Improved Compressor Design: 6512634

- 2009–2013 Toyota Corolla/Matrix
- 2008–2015 Scion xB
- 2003–2010 Pontiac Vibe

6512634

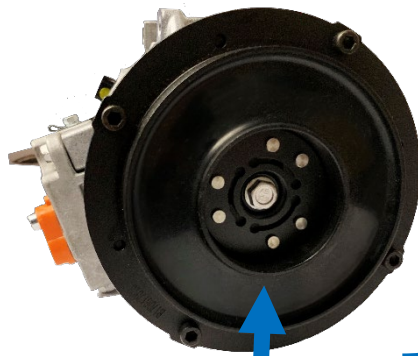
Rubber dampener on front of clutch reduces noise.

gpd compressor 6512634 also features an improved and more durable shaft assembly and control valve design.

Clutch surface is greater than OE style to accommodate a larger clutch bearing and stronger clutch coil.
